SECTION 96 SUBMISSION

DEE WHY RSL CLUB - 932 PITTWATER ROAD
STAGE 5 CLUB EXTENSION

THIS PLAN TO BE READ IN CONJUNCTION WITH
MOD2018/0119
NORTHERN BEACHES COUNCIL

PROJECT:
STAGE 5 - CLUB EXTENSION
PHASE 2 WORKS - SOUTHERN
CARPARK & ENCLOSURE

DRAWING TITLE:
CAR PARK LEVEL -3

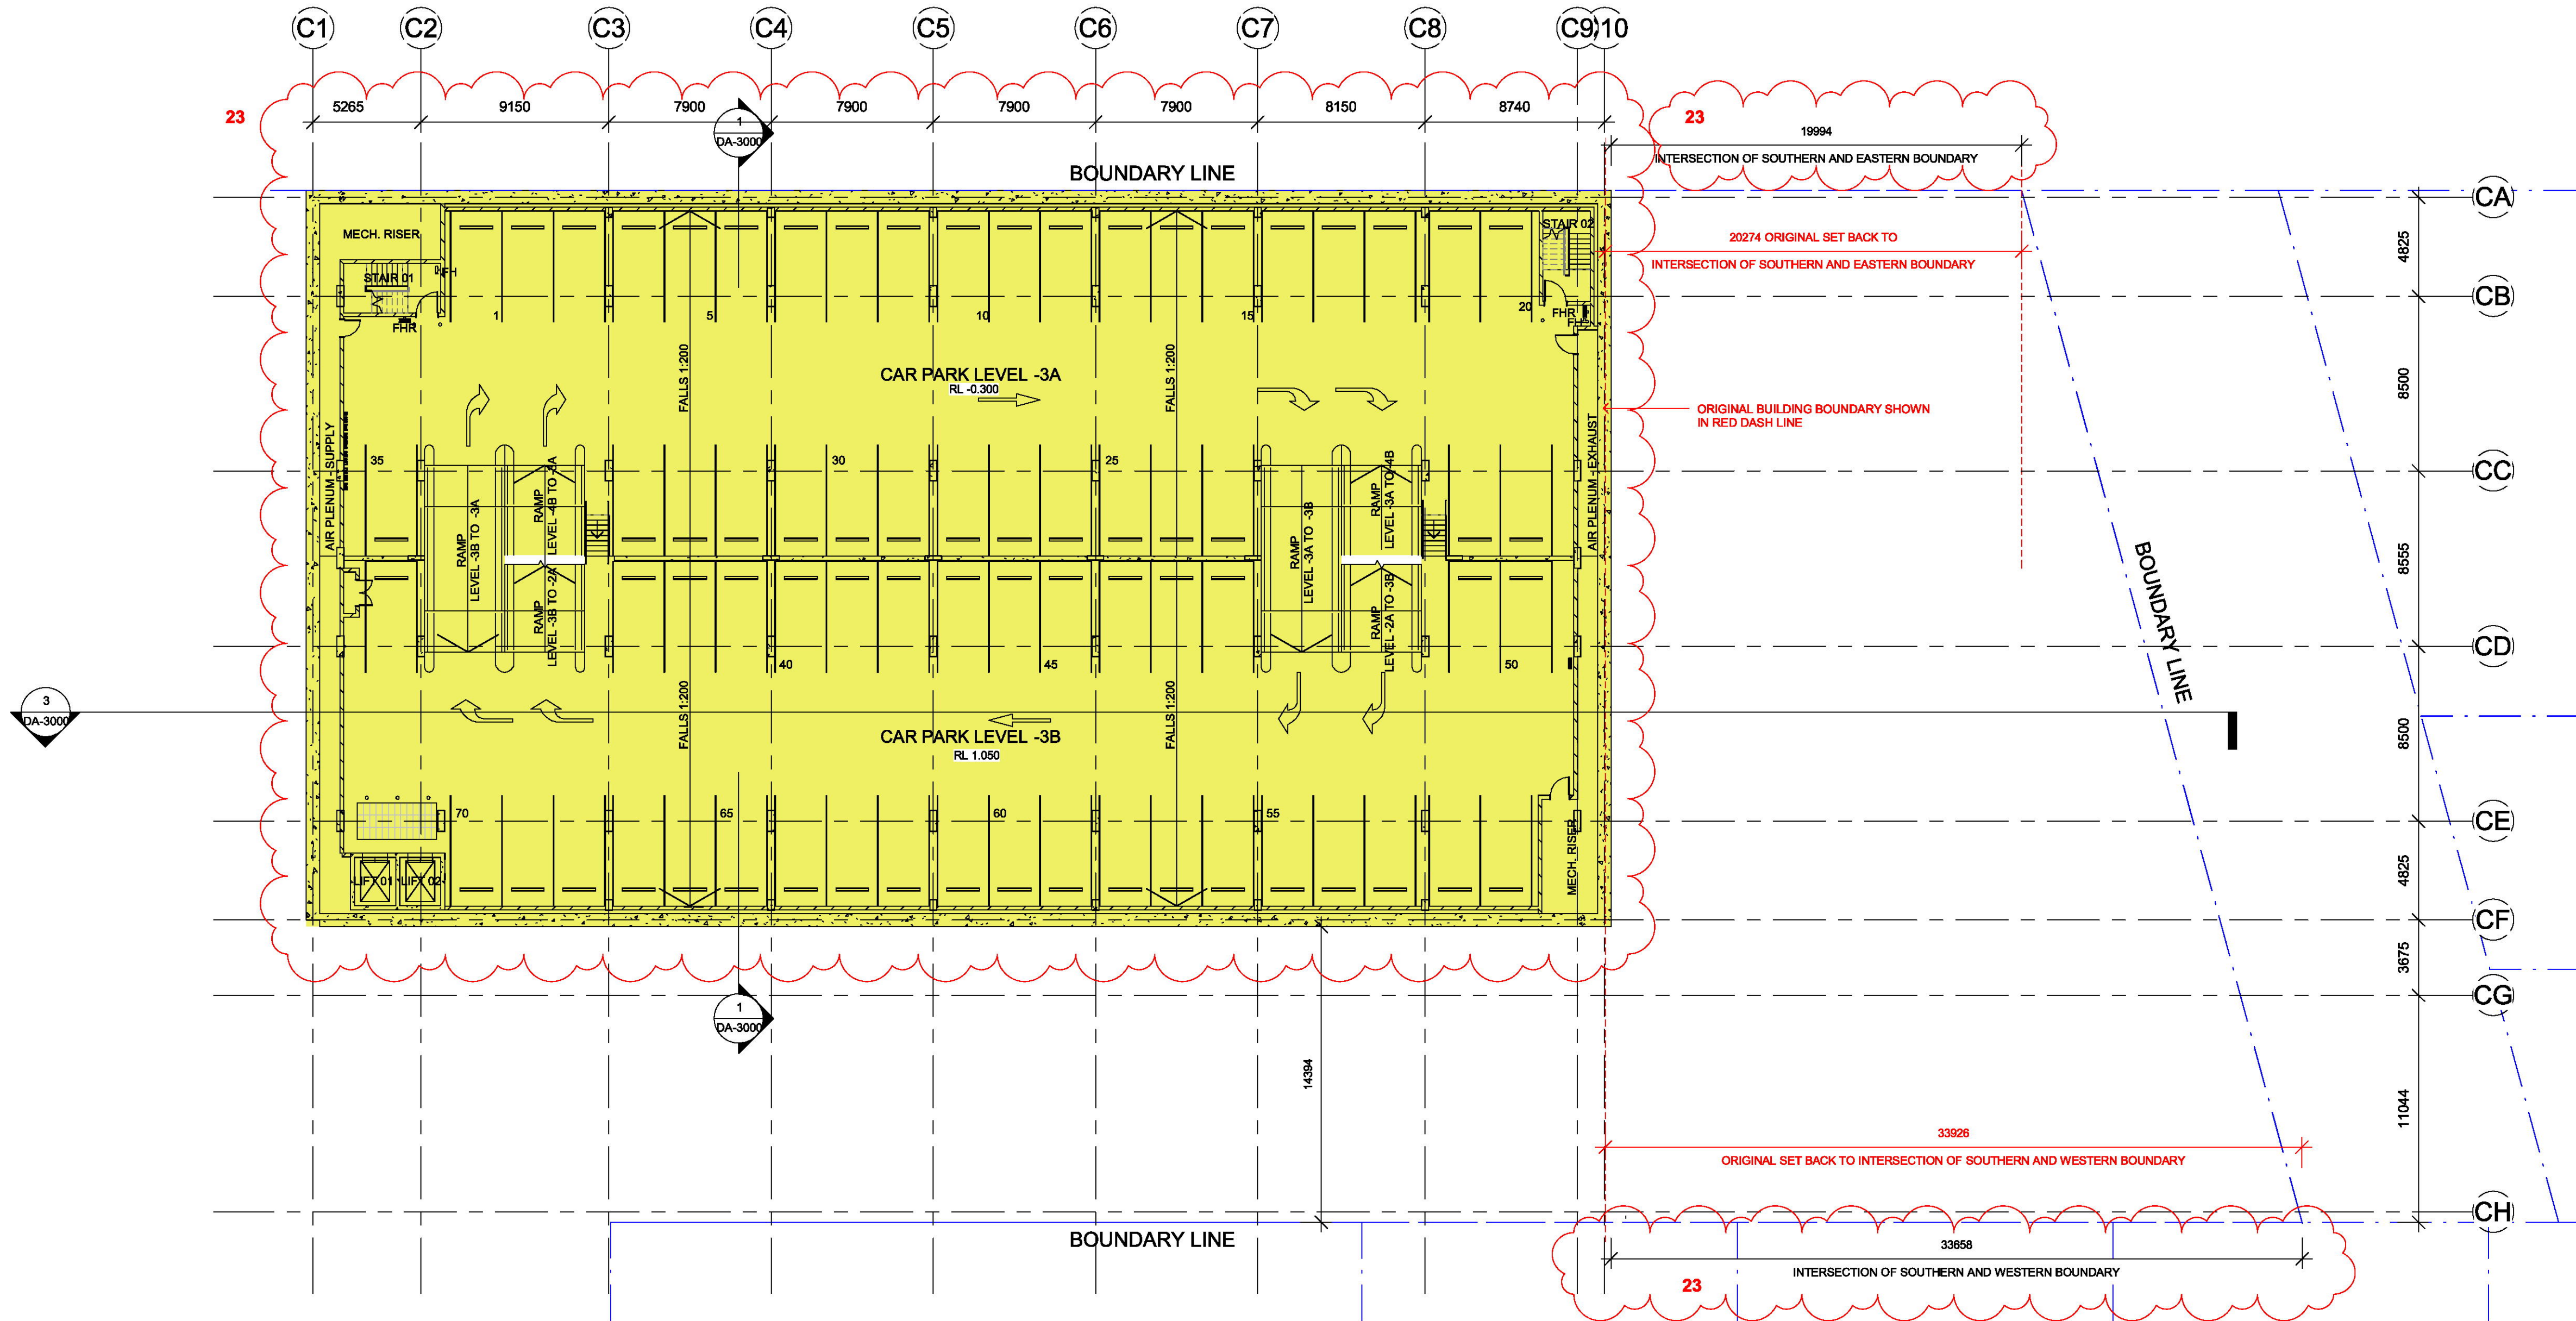
- CHANGES FOR SECTION 96 APPROVAL**
1. RELOCATED OPEN PLANTROOM AT THE ROOF LEVEL
2. MODIFIED ROOF OPENING ABOVE MAIN ENTRANCE
3. MODIFIED CENTRAL SKYLIGHT (REDUCED HEIGHT, MODIFIED PITCH)

4. MODIFIED COURTYARD: TWO OPEN COURTYARDS AND ONE SKYLIGHT COVERED AREA INSTEAD OF ONE LARGE GLASS ROOF. REDUCED HEIGHT AND PITCH
5. MODIFIED SMOKING TERRACE: ROOF OPENING, SIZE AND PLANTED AREA. AREA REDUCED BY 21m²

6. REDUCED NUMBER OF ROOF SKYLIGHTS ABOVE ASIAN RESTAURANT. 2 INSTEAD OF 6 TO SUIT THE NEW INTERNAL LAYOUT
7. MODIFIED EXIT STAIR: POSITION, CONFIGURATION, METAL ROOF NO LONGER REQUIRED

8. CONCRETE ROOF INSTEAD OF METAL DECK ROOF FOR THE MAJORITY OF THE BUILDING EXTENSION
9. NO SLAB ABOVE THE EXPOSED CAR PARK LEVEL 2 IN THE SOUTH AREA
10. NEW ACOUSTIC METAL ROOF ABOVE REVISED LOADING DOCK

- facade**
11. MODIFIED FACADE APPEARANCE DUE TO CHANGES IN THE CAR PARK LEVELS, LOADING DOCK AND EGRESS STAIRS
12. REMOVED LOUVRES ON THE BACK FACADE (WESTERN FACADE) DUE TO MECHANICAL RISER NO LONGER REQUIRED / REVISED LOCATION FOR EGRESS DOORS

13. 2m WIDE INTERNAL EGRESS STAIR MODIFIED INTO TWO 1m WIDE EXTERNAL STAIRS WITH DECORATIVE BALUSTRADES
14. EXTENT OF LEVEL 2 (MAIN TRADING LEVEL) REDUCED BY 8326mm FROM THE SOUTHERN BOUNDARY AND INCREASED BY 1100mm TO THE EASTERN BOUNDARY

15. MODIFIED FACADE CURTAIN WALL MULLION BLADES
16. CONCRETE BLADE WALL REDUCED BY 1.47m IN HEIGHT AND 6.2m IN LENGTH
17. VERTICAL FINS REMOVED FROM BACK WALL (WESTERN FACADE)

- ground/landscape/floor plate**
18. REVISED LOADING DOCK ENTRANCE AND LOCATION/ ENLARGED DEMOLISHED AREA IN THE EXISTING RETAINED SOUTHERN CAR PARK
19. NEW / MODIFIED EGRESS PATHS FROM EXISTING CARPARK LEVEL -1. NEW CARPARK LEVEL 1.

20. RELOCATED ELECTRICAL SUBSTATION / LANDSCAPED AREA MOVED TO SUIT
21. MEDIAN STRIP ADDED AT ENTRY TO PROVIDE PLACE OF REFUGE AND ENSURE WIDTH OF ENTRY/ EXIT IS LESS THAN 8m AS PER DA CONDITION 23

24. BASEMENT CAR PARK LEVEL -5 ADDED.
25. CAR PARK ENTRY / EXIT MOVED TOWARD NORTH BY 3044mm
26. PLANTER MODIFIED ON THE BACK (WESTERN) FACADE DUE TO REDUCTION OF THE MAIN TRADING FLOOR SLAB

27. LOCATION OF AIR INTAKE MODIFIED
28. EXTENT OF RESTAURANT REDUCED BY 136m²
29. CLUB ENTRANCE ACCESSIBLE RAMP MODIFIED
30. ONE ADDITIONAL EXISTING CAR PARK SPACE TO BE REMOVED FROM EXISTING NORTHERN CAR PARK

31. SOLID MASONRY WALL ADDED BETWEEN EXISTING ZONE D CAR PARK AND LOADING DOCK ACCESS.

DRAWING TITLE: CAR PARK LEVEL -2

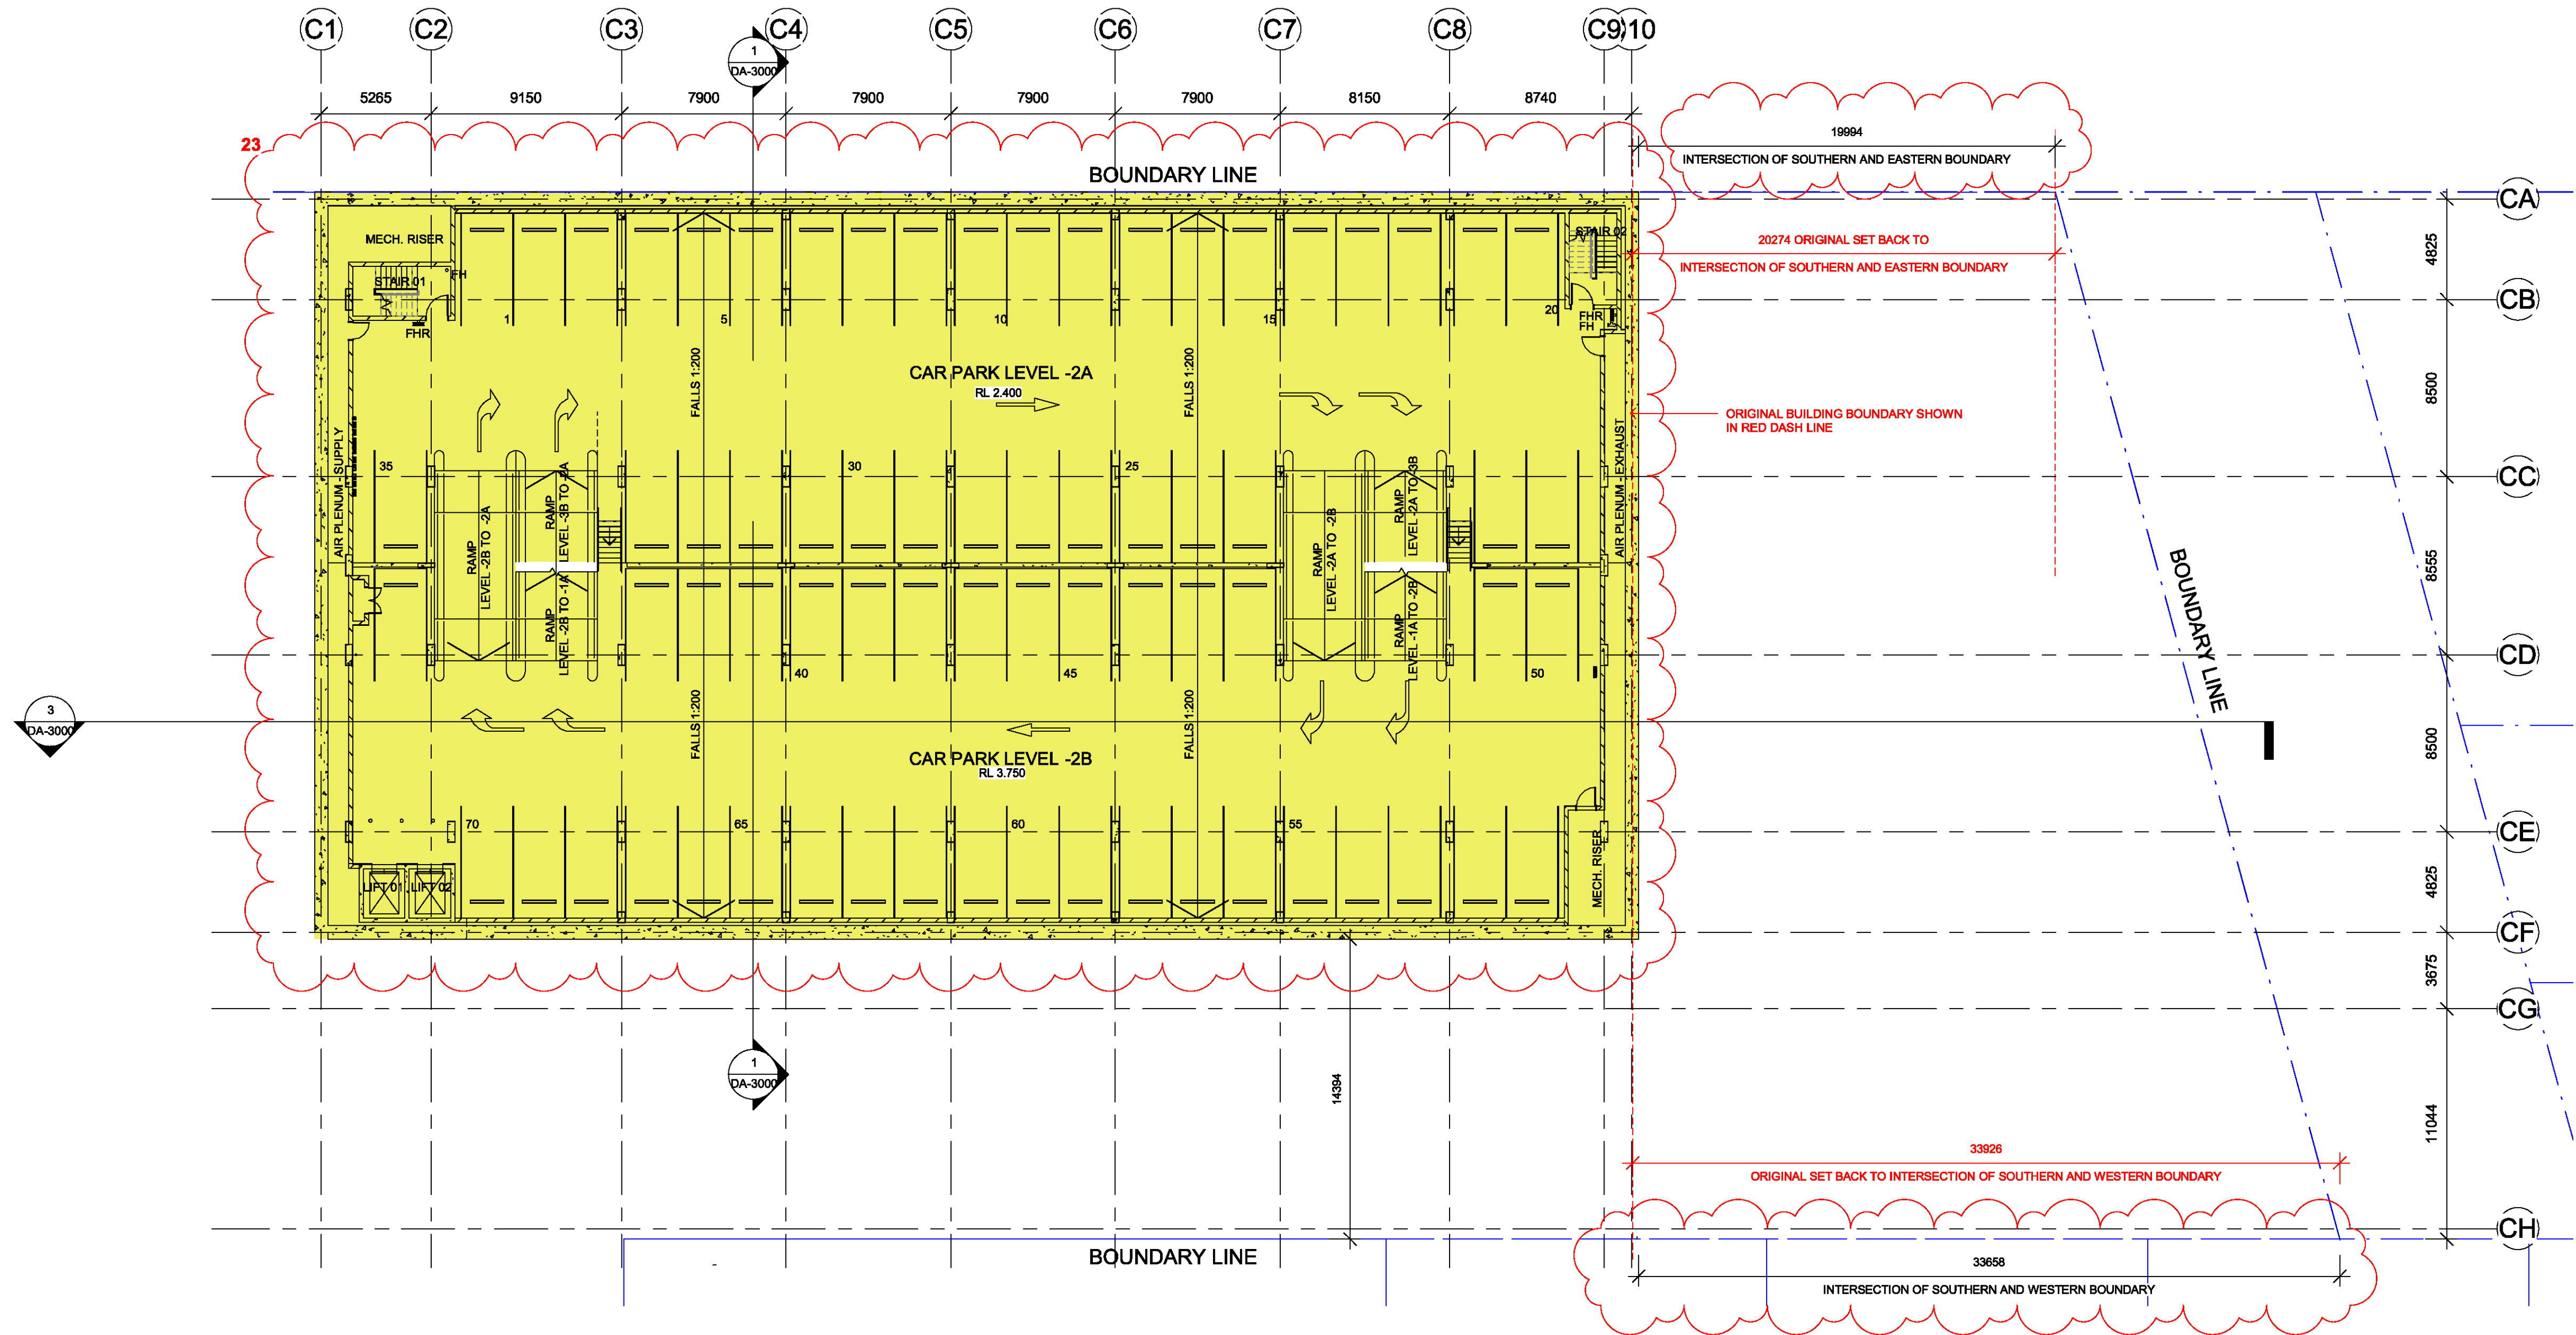
1. RELOCATED OPEN PLANTROOM AT THE ROOF LEVEL
2. MODIFIED ROOF OPENING ABOVE MAIN ENTRANCE
3. MODIFIED CENTRAL SKYLIGHT (REDUCED HEIGHT, MODIFIED PITCH)
4. MODIFIED COURTYARD: TWO OPEN COURTYARDS AND ONE SKYLIGHT COVERED AREA INSTEAD OF ONE LARGE GLASS ROOF. REDUCED HEIGHT AND PITCH
5. MODIFIED SMOKING TERRACE: ROOF OPENING, SIZE AND PLANTED AREA, AREA REDUCED BY 21m²
6. REDUCED NUMBER OF ROOF SKYLIGHTS ABOVE ASIAN RESTAURANT: 2 INSTEAD OF 6 TO SUIT THE NEW INTERNAL LAYOUT
7. MODIFIED EXIT STAIR: POSITION, CONFIGURATION, METAL ROOF NO LONGER REQUIRED
8. CONCRETE ROOF INSTEAD OF METAL DECK ROOF FOR THE MAJORITY OF THE BUILDING EXTENSION
9. NO SLAB ABOVE THE EXPOSED CAR PARK LEVEL 2 IN THE SOUTH AREA
10. NEW ACOUSTIC METAL ROOF ABOVE REVISED LOADING DOCK

11. MODIFIED FACADE APPEARANCE DUE TO CHANGES IN THE CAR PARK LEVELS, LOADING DOCK AND EGRESS STAIRS
12. REMOVED LOUVRES ON THE BACK FACADE (WESTERN FACADE) DUE TO MECHANICAL RISER NO LONGER REQUIRED / REVISED LOCATION FOR EGRESS DOORS
13. 2m WIDE INTERNAL EGRESS STAIR MODIFIED INTO TWO 1m WIDE EXTERNAL STAIRS WITH DECORATIVE BALUSTRADES
14. EXTENT OF LEVEL 2 (MAIN TRADING LEVEL) REDUCED BY 832mm FROM THE SOUTHERN BOUNDARY AND INCREASED BY 1100mm TO THE EASTERN BOUNDARY
15. MODIFIED FACADE CURTAIN WALL MULLION BLADES
16. CONCRETE BLADE WALL, REDUCED BY 1.47m IN HEIGHT AND 8.2m IN LENGTH
17. VERTICAL FINS REMOVED FROM BACK WALL (WESTERN FACADE)

18. REVISED LOADING DOCK ENTRANCE AND LOCATION/ ENLARGED DEMOLISHED AREA IN THE EXISTING RETAINED SOUTHERN CAR PARK
19. NEW / MODIFIED EGRESS PATHS FROM EXISTING CARPARK LEVEL -1. NEW CARPARK LEVEL 1.

20. RELOCATED ELECTRICAL SUBSTATION / LANDSCAPED AREA MOVED TO SUIT
21. MEDIAN STRIP ADDED AT ENTRY TO PROVIDE PLACE OF REFUGE AND ENSURE WIDTH OF ENTRY/ EXIT IS LESS THAN 8M AS PER DA CONDITION 23

24. BASEMENT CAR PARK LEVEL -5 ADDED.
25. CAR PARK ENTRY / EXIT MOVED TOWARD NORTH BY 3044mm
26. PLANTER MODIFIED ON THE BACK (WESTERN) FACADE DUE TO REDUCTION OF THE MAIN TRADING FLOOR SLAB

27. LOCATION OF AIR INTAKE MODIFIED
28. EXTENT OF RESTAURANT REDUCED BY 136m²
29. CLUB ENTRANCE ACCESSIBLE RAMPS MODIFIED
30. ONE ADDITIONAL EXISTING CAR PARK SPACE TO BE REMOVED FROM EXISTING NORTHERN CAR PARK

31. SOLID MASONRY WALL ADDED BETWEEN EXISTING ZONE D CAR PARK AND LOADING DOCK ACCESS.
